**TOWN COUNCIL ACTION ITEM  
STAFF REPORT  
FEBRUARY 5, 2019 TOWN COUNCIL MEETING**

**DATE:** January 31, 2019

**AGENDA ITEM NUMBER:** 5

**AN ORDINANCE APPROVING A LEVEL IV DEVELOPMENT  
APPLICATION FOR A MAJOR AMENDMENT TO THE DILLON  
HOMEWOOD SUITES PUD DEVELOPMENT PLAN.**

**Figure 1.** View of the southeastern portion of the building – Approved PUD

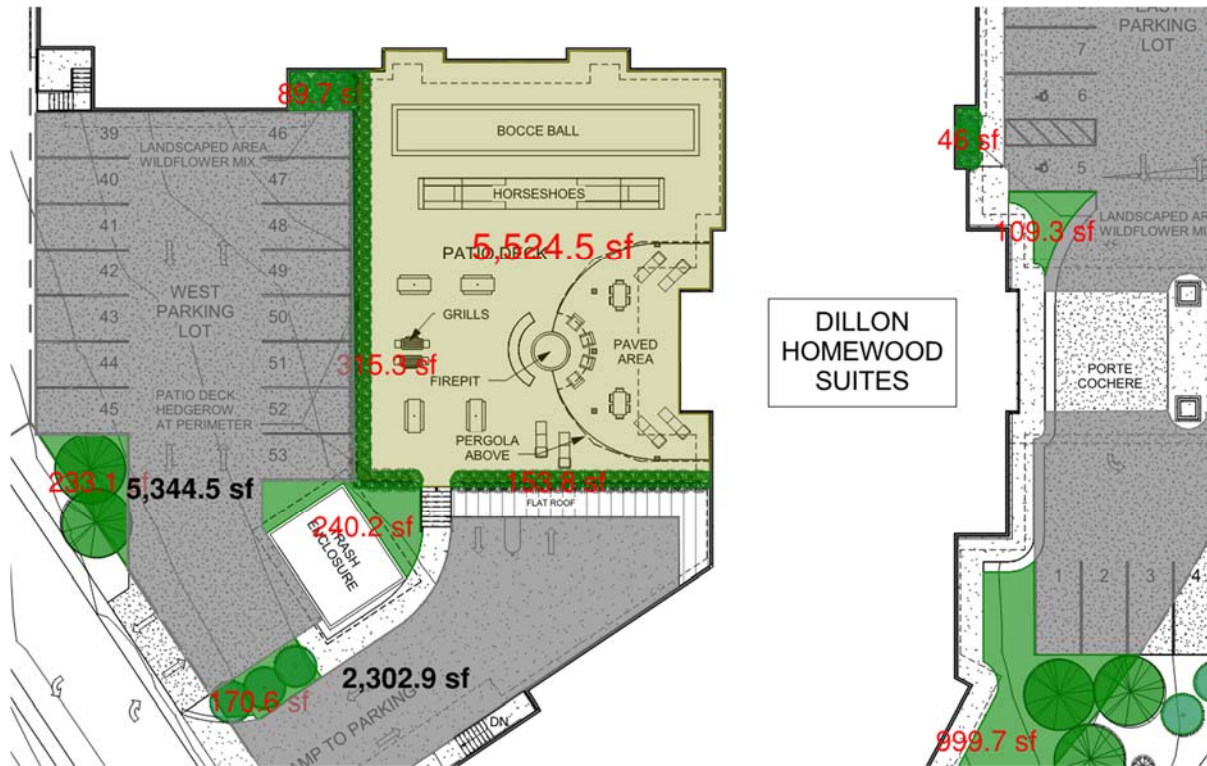
The architectural design remains very much the same as the approved PUD Development Plan. The rooftop restaurant is reduced to a bar area with a smaller roof, thus removing some of the mass from that portion of the building. The bar still has an exterior deck space; however, the deck is reduced on the Lake Dillon Drive side of the building. The reduced use of the rooftop restaurant to a bar space is a noted change with this Major PUD Amendment. The bar use remains a hotel guest amenity, as was the previously approved restaurant use. See Figures 1 & 2 for a comparison of the previous approval and the proposed amendment for the southeastern portion of the building.

**Figure 3.** View of the previously approved architecture of the Porte Chochere

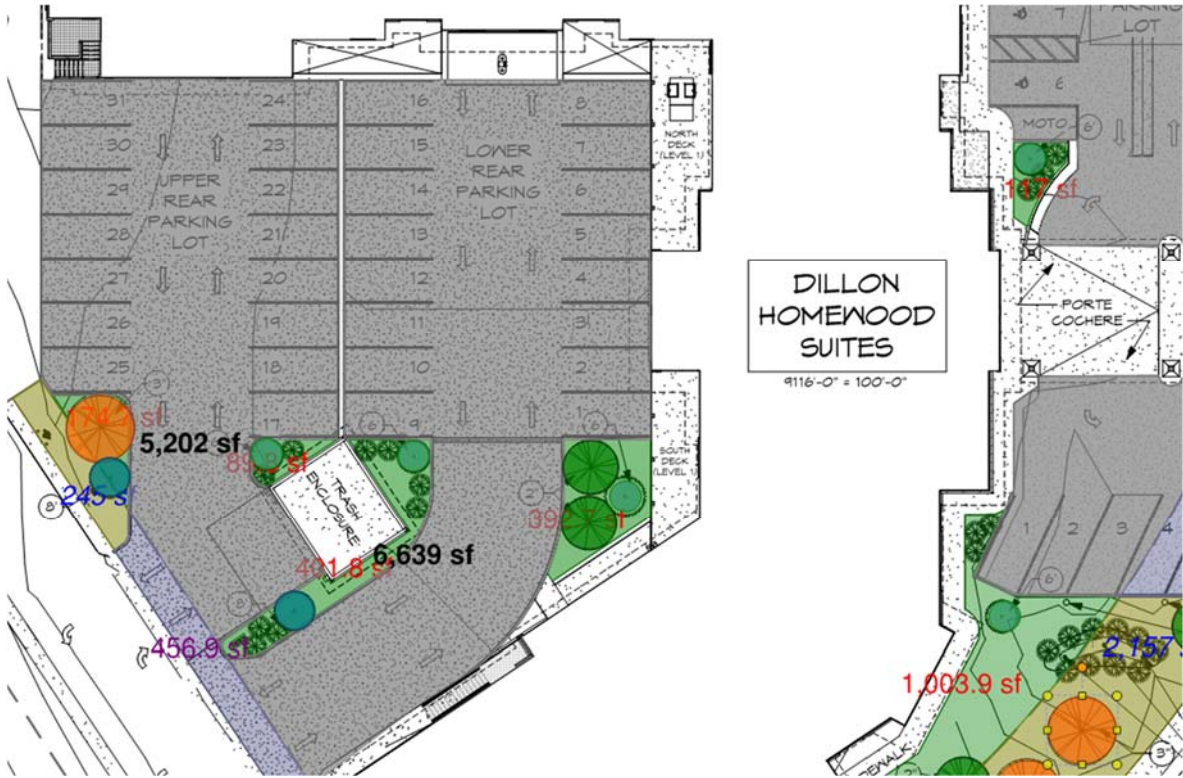
Other noteworthy building design changes are the elimination of the recreation deck over parking on the back of the building and changes to the Porte Cochere column design. The Porte Cochere columns are reduced from massive stone columns to timber posts with stone bases (see figures 3 & 4). The parking remains but is no longer covered where the recreation deck previously was located. The structured parking is therefore changed as well, with less parking being within the structure, and additional exterior parking (see figures 5 & 6).

Figure 8. Relative Building Height

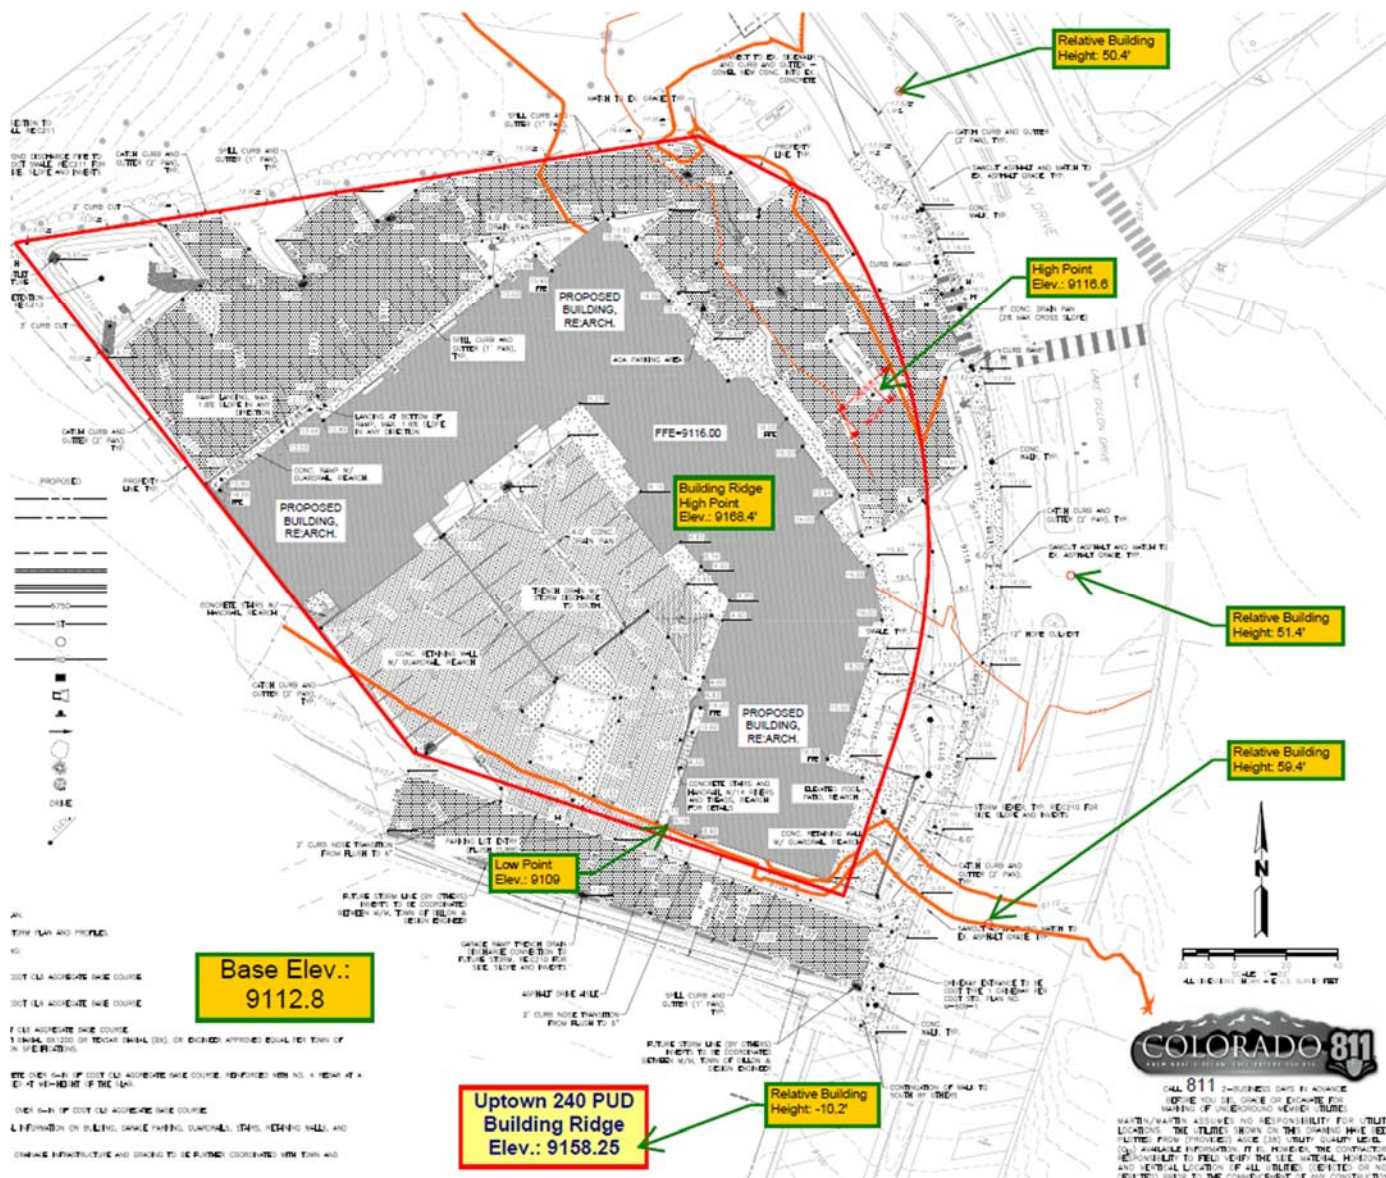
The site plan with the high and low points identified may be viewed in Figure 8.

Building Height	Elevation
High Existing Ground Elevation	9116.6'
Low Existing Ground Elevation	9109.0'
Base Elevation	9112.8'
Max. Peak Elevation of Building	9168.4'
<b>Calculated Building Height</b>	<b>55.6'</b>
<b>Max. Permitted Building Height</b>	<b>56.25' *</b>

Figure 9. Building Height

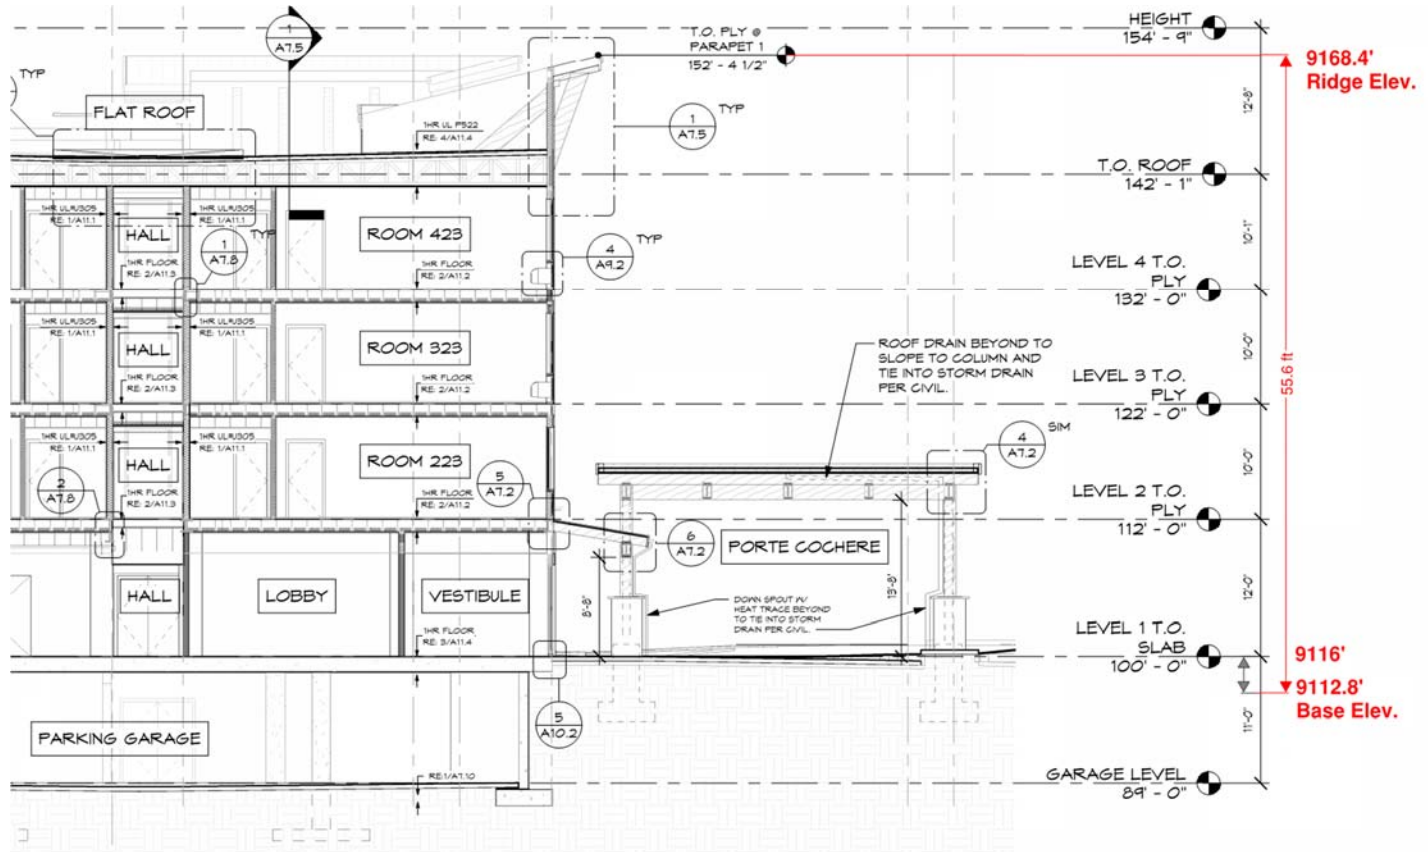
The base elevation for the site is determined to be 9,112.8' feet above sea level. The Application has a maximum peak elevation of 9,168.4' (Arch: 152' - 4 1/2" See Plan Sheet A6.0 & Figure 9). The Building Height for this Application is 55.6' as determined by Town Code; however, the previously approved maximum building height of 56.25 feet remains the maximum permitted height for the Application.

**Figure 10. Setbacks / Yards**

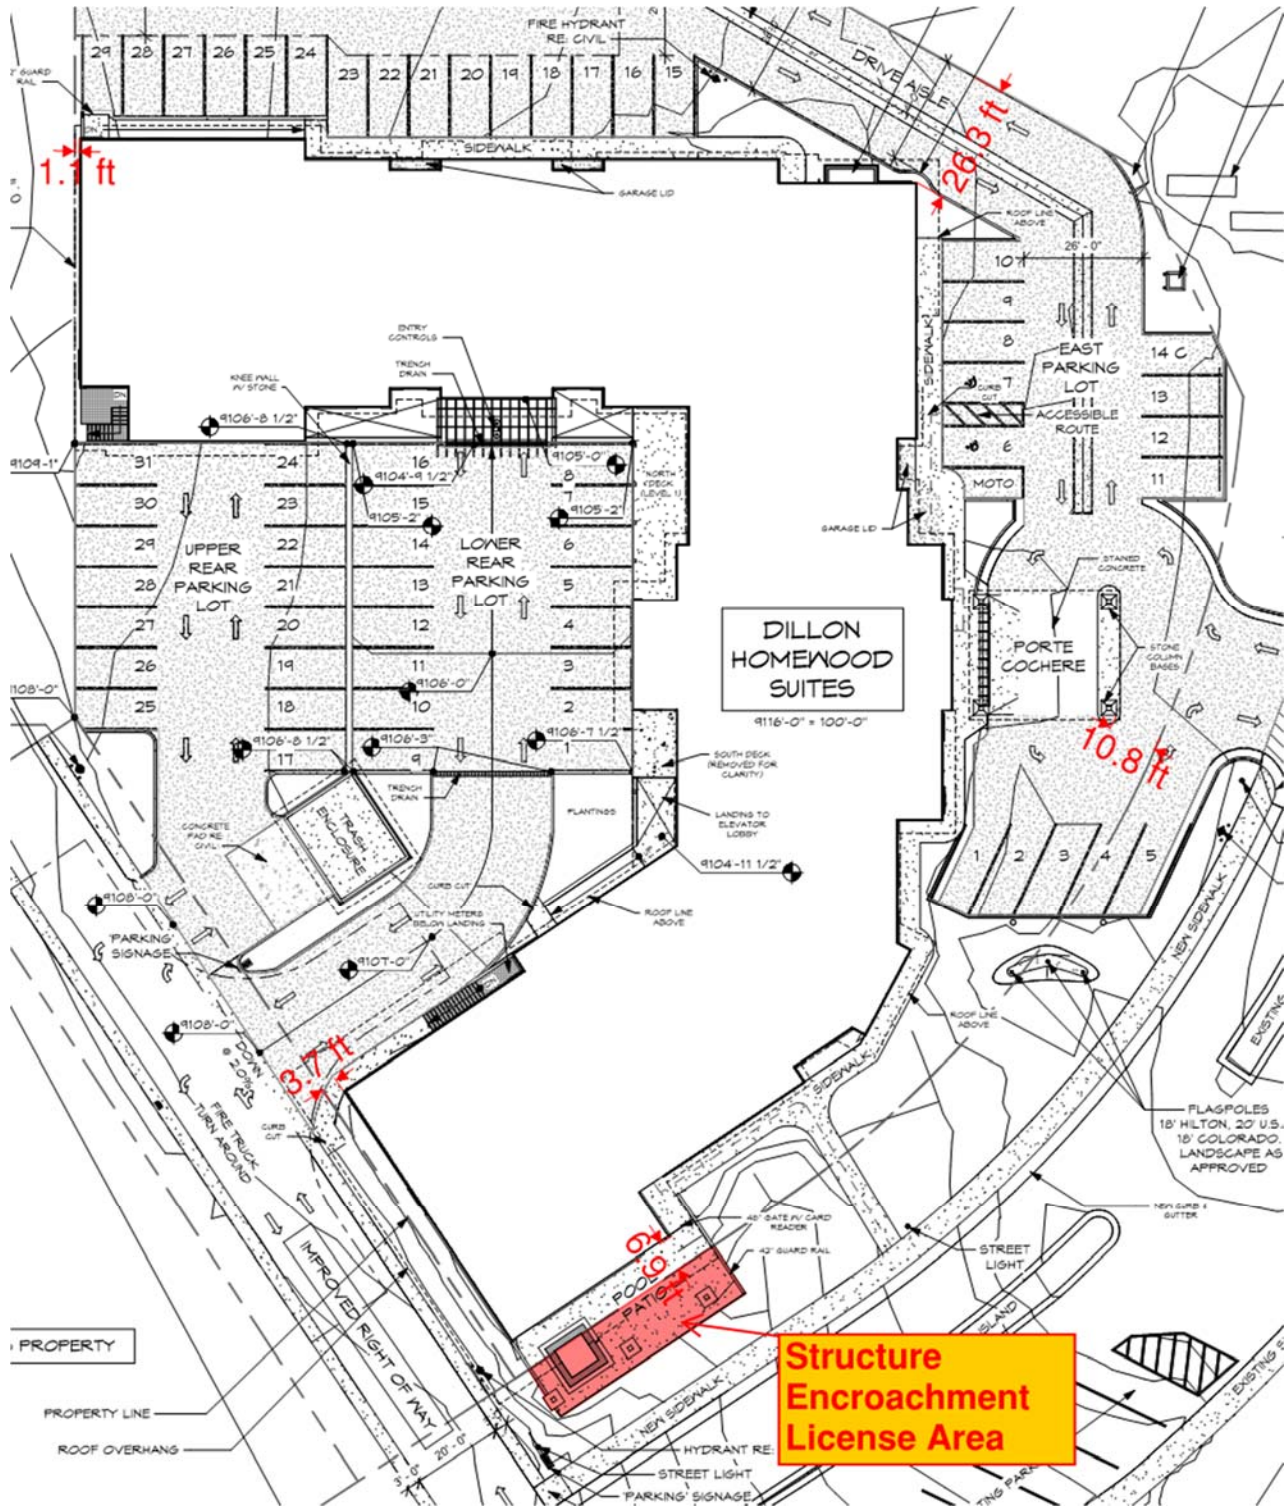
The setbacks remain essentially unchanged with this Application, and those yards previously approved remain for this Application.

The Application also has a portion of the structure within the Lake Dillon Drive Right of way in an encroachment license area. This encroachment area, that of the parking lot, as well as the directory and monument signage were previously approved with the existing PUD. The
